# IREDELL COUNTY HEALTH DEPARTMENT

## (SEPTIC TANK) IMPROVEMENTS PERMIT AND CERTIFICATE OF COMPLETION
(Ground Absorption Sewage Disposal System – G. S. Chapter 130-Article 13C)

SUBDIVISION NAME Lake Norman LOT NO. 47 SECTION OR BLOCK NO. 15

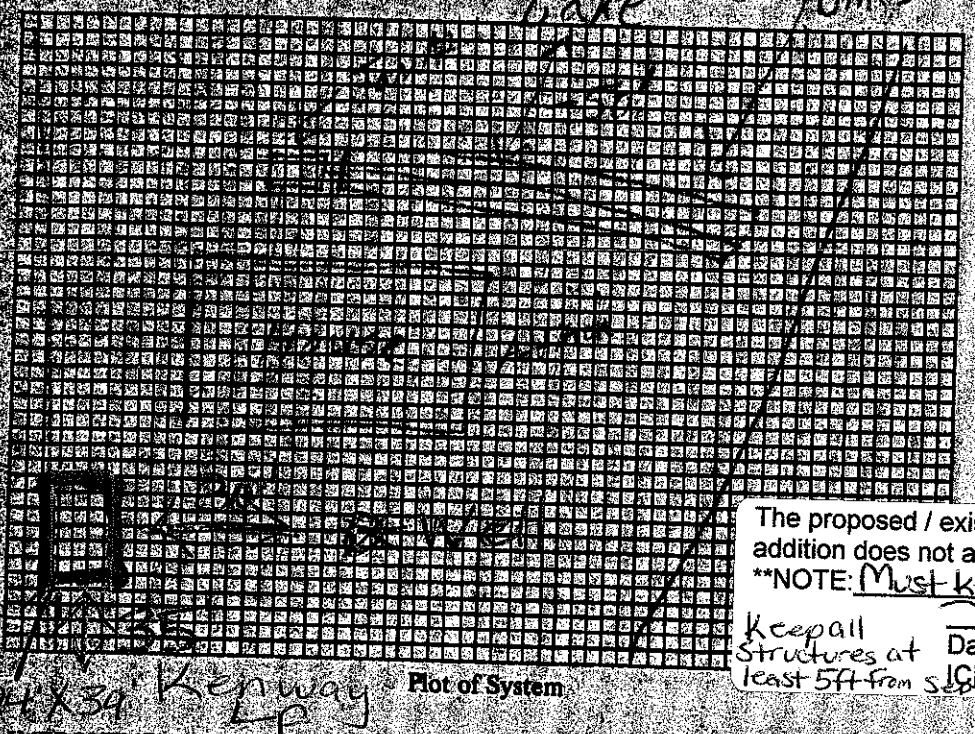
The proposed / existing 24'x34' Garage addition does not appear to impact the existing septic system.
**NOTE: Must keep at least 25ft from well
Keep all Structures at least 5ft from septic

COMMENTS: System is adequate for additional
